CERTIFICATE OF APPROPRIATENESS

Property: 848 Heights Boulevard, Lot 24, Block 247, Houston Heights South Subdivision. The property includes a historic two-story brick single-family residence and an attached garage situated on a 5,000 square foot (50' x 100') corner lot.

Proposal: Alteration – Revision. Construct a partial wall along the southern elevation of the addition between the addition and proposed garage.

**SOUTH ELEVATION**

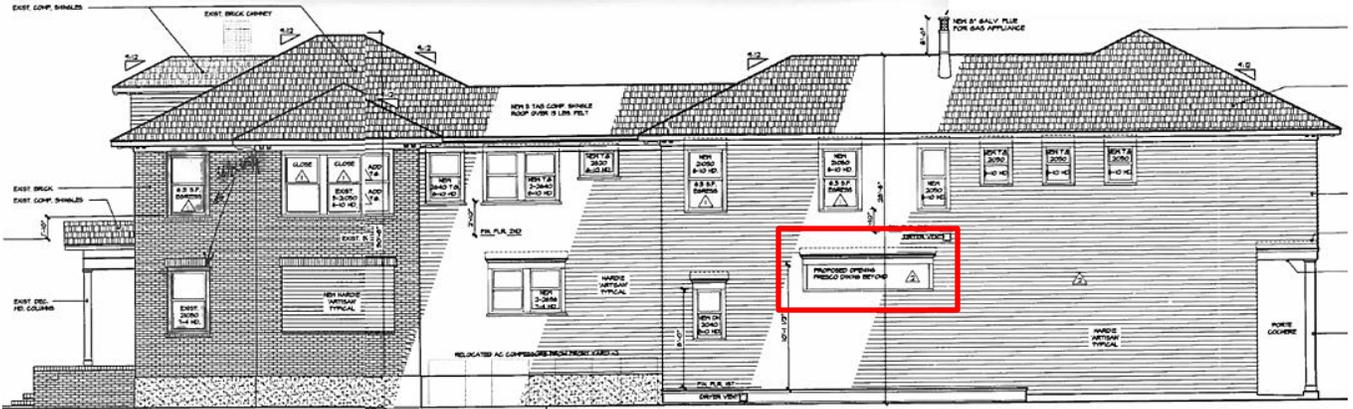
- As originally approved, the first story of this portion of the addition was not enclosed
The proposed wall will include a horizontal opening which will be 11'-1" wide by 1'-5" tall and will be located 6'-10" above the finished floor
The proposed alteration will be visible from E 9th Street since this is a corner property
The work has already been completed

Recommendation: Approval

HAHC Action: Approved
